Work Order ID 104960

Item ID: D4634-041 Accept ***N900040100*** Setup Start ***NS1***
 Revision ID: Stop ***NS2***
 Item Name: Fwd, Center Ceiling Panel Assembly
 Start Date: 7/23/13 Start Qty: 1.00 ***1*** Cust Item ID:
 Required Date: 7/23/13 Req'd Qty: 1.00 ***1*** Customer:
 Reference:

D4634-041 FWD, CENTER CEILING PANEL ASSY

REWORK DOUBLER

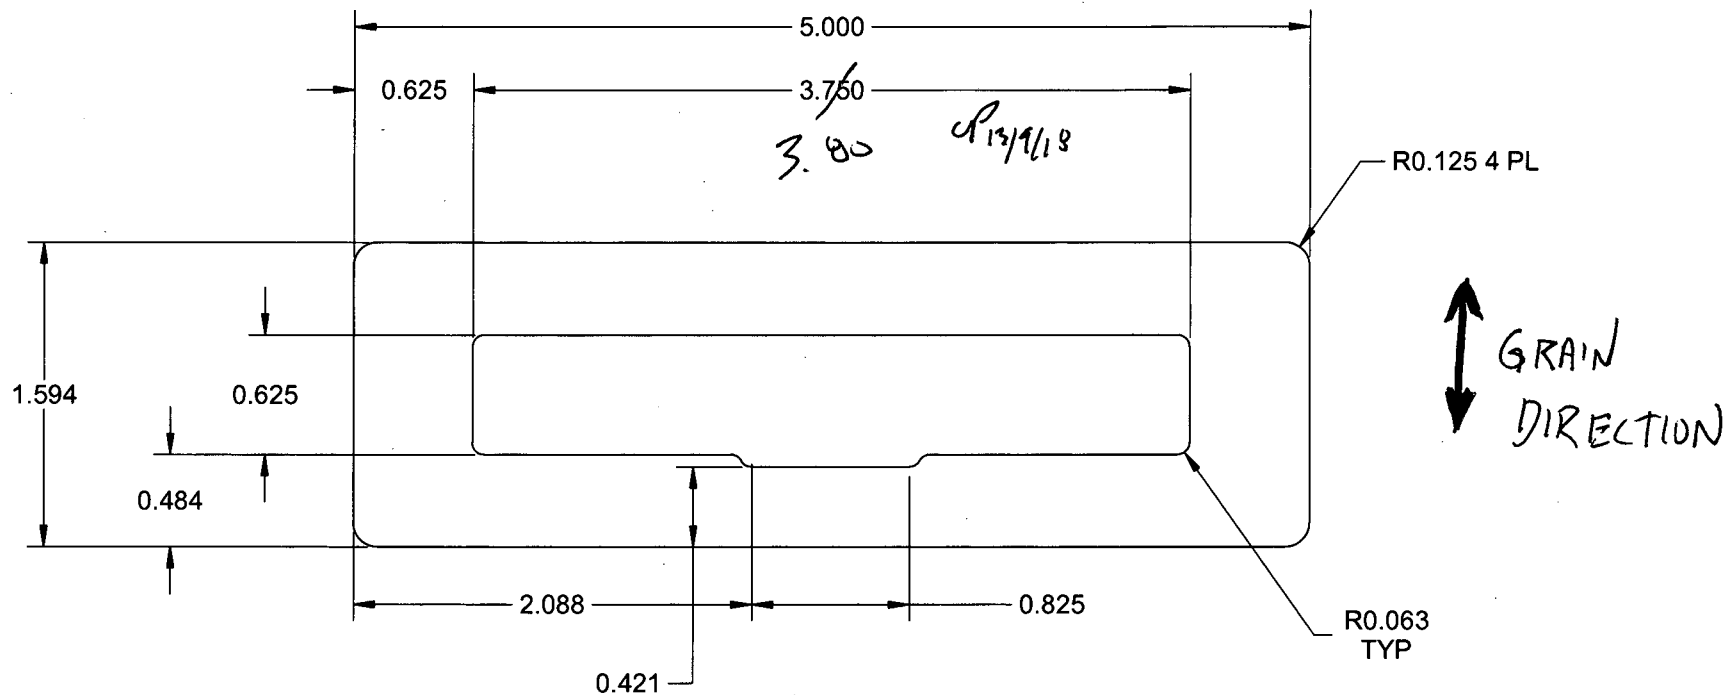
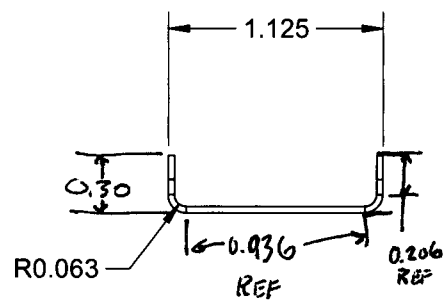
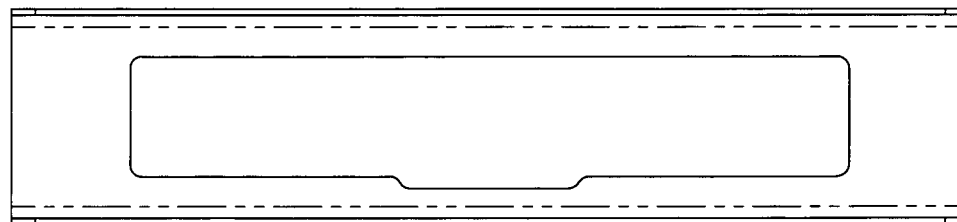
Root Cause	Date	Step	Qty	Description of work order update or Non-conformance	Initial Chief Eng	Action Description	Sign & Date	Verification	QC Inspector
Doc/Data	13/9/18	110	1	Opening for advisory light cut too wide (3.96"). Light does not fit (falls out). RC Design issue + was tube too large due to Poor Tooling	CP 13/9/18	Cut 5.00x1.544 doubler. 6061-T6, 0.032 thick. M6061T6S.032 BIN 123483	AC 13/09/18	CP 13/9/18	13/09/19 DAS 16 9-09 13/09/19
Equip/Tooling					CP 13/9/18	Bend to 1.12 total width with 20.15 BENDS. Ro.063	SB 13/09/18	SB 13-09-19	
Operator					CP 13/9/18	Chemical conversion coat per Q51 005 4.1	2/13 13-9-18	MW 13-09-19	
Material					CP 13/9/18	Install in panel as backing for advisory light.	DK 13/09/19	S 13/09/19	
Setup									
Other									
Process									
Supplier									
Training									
Unapproved

REWORK DOUBLER P13/9/18

6061-T6, 0.032 thick
M6061T6S.032
